Access Compliance Report

Public Rights-of-Way

(Curb Ramps)

Intersection ID: 15785	Main Street: CHEROKEE_PL	Cross Street: COLVILLE_RD	Location: NE
ADA ID: AC9A203E1EA3	Ramp Type: Perp	Initial Pass/Fail: Fail	Overall Compliance: No
			Severity Score: 21.25

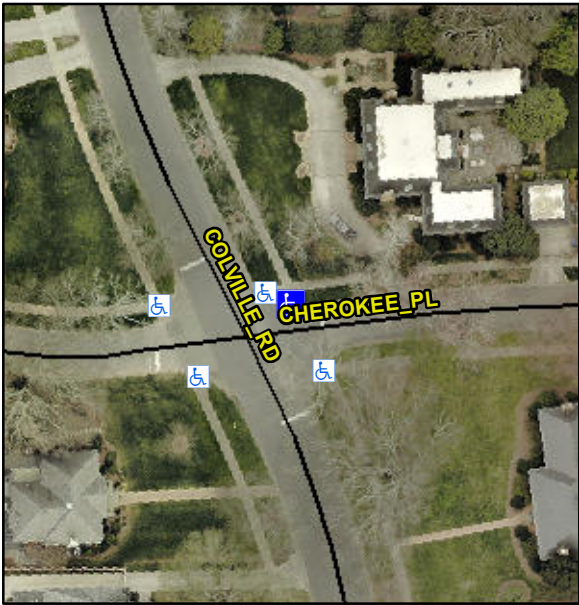
Codes/Mitigation Info/Possible Solution			Field Measurements/Component Compliance					
	Possible Solutions:		Compliance	Description	Data	Compliance	Description	Data
	Remove & Replace Entire Ramp.		N/A	Ramp Length (in)	72.0	No	Ramp Slope (%)	8.7
			No	Ramp Width (in)	47.0	Yes	Ramp XSlope (%)	1.2
			N/A	Flare Type LT	N/A	N/A	Flare Type RT	N/A
			N/A	Flare Slope LT (%)	N/A	N/A	Flare Slope RT (%)	N/A
			N/A	Flare Traversable LT?	N/A	N/A	Flare Traversable RT?	N/A
			N/A	Landing Length (in)	N/A	N/A	DWS Provided?	N/A
			N/A	Landing Width (in)	N/A	N/A	DWS Contrast?	N/A
			N/A	Landing Slope (%)	N/A	N/A	DWS Length (in)	N/A
			N/A	Landing X Slope (%)	N/A	N/A	DWS Full Width?	N/A
Surveyor Notes:	N/A		N/A	Landing Curb? (Y/N)	N/A	N/A	DWS Offset (in)	N/A
			N/A	Shared Landing?	N/A			
	PROW/ADA:		N/A	Gutter Ponding?	N/A	N/A	Gutter Slope (%)	N/A
	Not Found, R304.5.1, R304.2.2		N/A	Gutter Lip Ht (in)	N/A	N/A	Gutter X Slope (%)	N/A
